CITY OF GROSSE POINTE WOODS, MICHIGAN
20025 Mack Plaza Dr.
Rescheduled Planning Commission Meeting
Tuesday, September 22, 2015
7:30 p.m.

7. **SITE PLAN REVIEW: SCREEN FOR ROOFTOP MECHANICAL UNIT, CHURCHILL'S BISTRO CIGAR BAR, 19271 MACK AVE:**
   A. PC Excerpt – 10/28/14
   B. Memo – Public Safety – *will be distributed at PC meeting*
   C. Memo – Building Official (Tutag) – 09/15/15
   D. Photos (5) – 09/01/15 & 09/10/15
   E. Munters Energy Saving Systems Submittal (32 pgs) – 02/19/15
   F. Multi-Wing Optimiser Specs Sheet – 08/18/15
   G. Option "A" – Proposed Elevations A-4A – 09/14/15
   H. Option "A" – Roof Plan and Details A-6A – 09/14/15
   I. Option "B" – Proposed Elevations A-4B – 09/14/15
   J. Option "B" – Roof Plan and Details A-6B – 09/14/15

SUBJECT: Review of Rooftop HVAC Unit
Churchill's Cigar Bar, 19271 Mack Avenue

Option "B"
Proposed
Elevations

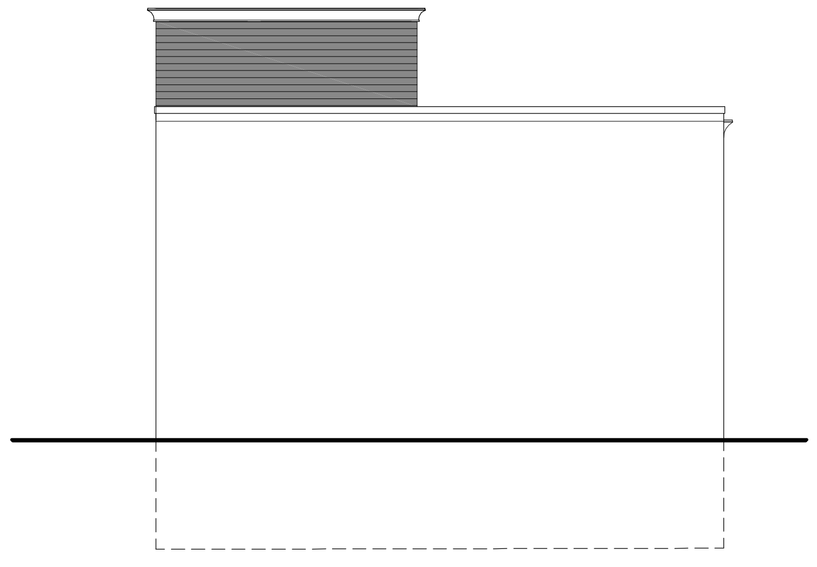
The second option involves constructing an enclosure around the unit that would look like a third story to the building as this option has doors, windows, siding, and trim matching the existing building's design.

Regardless, either option will become a significant visual feature of the building.
